Title: Advisory Committee on Reactor Safeguards
Metallurgy and Reactor Fuels Subcommittee

Date: Tuesday, September 17, 2019

ACRS Subcommittee Meeting: Draft Interim Staff Guidance for Chromium-Coated Cladding

Vendor example of coated cladding

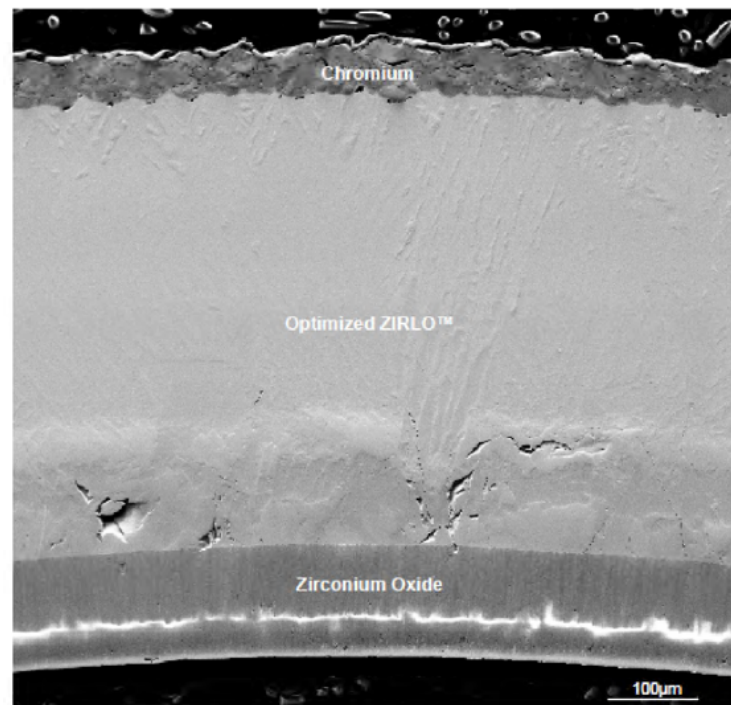
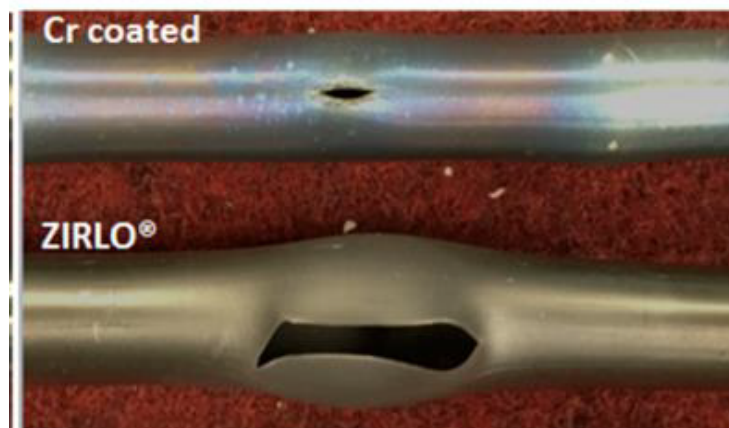
15 MEMBER KIRCHNER: Then let me ask a
16 question since we're ahead. Just a clarification.
17 The Slide No. 5, 1,800 psi, is that internal pressure?

22 MEMBER KIRCHNER: No, I know. I just want
23 to clarify it wasn't external pressure. It's the
24 internal pressure.
